Vehicle	FIAT / Stilo 1.9 JTD 8V / 10/2001 - 12/2003 / Лимузина стръмен наклон отзад
Country of manufacture	I
Cubic capacity/Power	1.9 / 85 kW
Motor tag	192 A 1.000
RB key	FIA 1618

## Known fixes and bulletins

### Bulletin

AB 114152

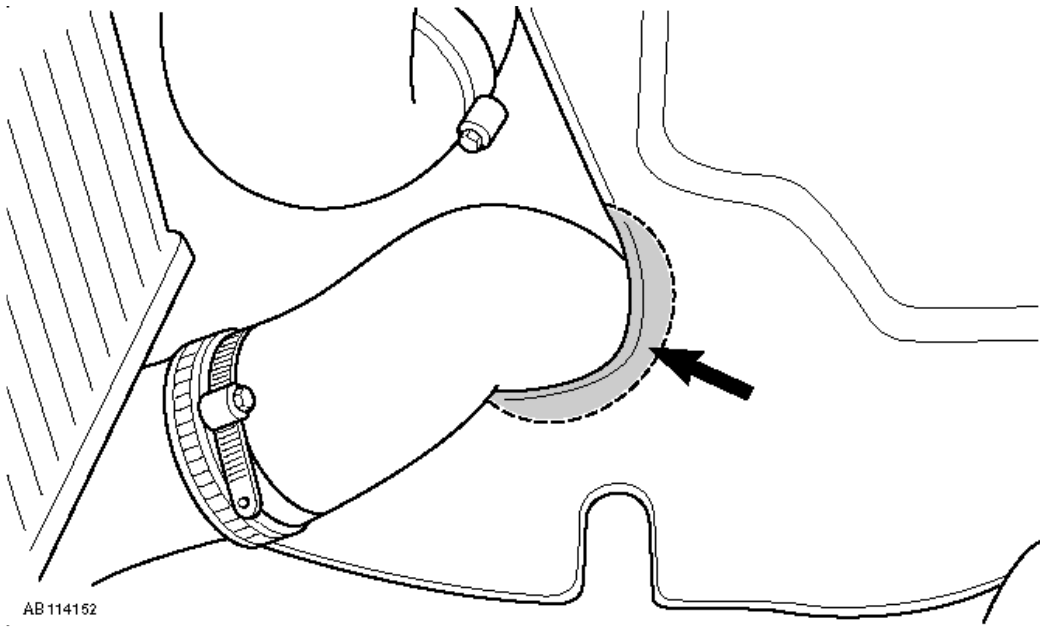
- Poor engine performance.
- Whistling noise from turbocharger (TC) during boost phase.

- Rubber intercooler hose from turbocharger (TC) outlet pipe rubs against engine acoustic cover, causing hose to split.

- Increase the clearance between the rubber intercooler hose and the engine acoustic cover Fig.1.
- Remove damaged rubber intercooler hose.
- Fit new rubber intercooler hose, ensure that the securing clips on the top and bottom rubber hoses are located centrally between the pipe bulges.

**NOTE: The clearance between the intercooler hose and acoustic cover must be at least 15 mm.Fig.114152**
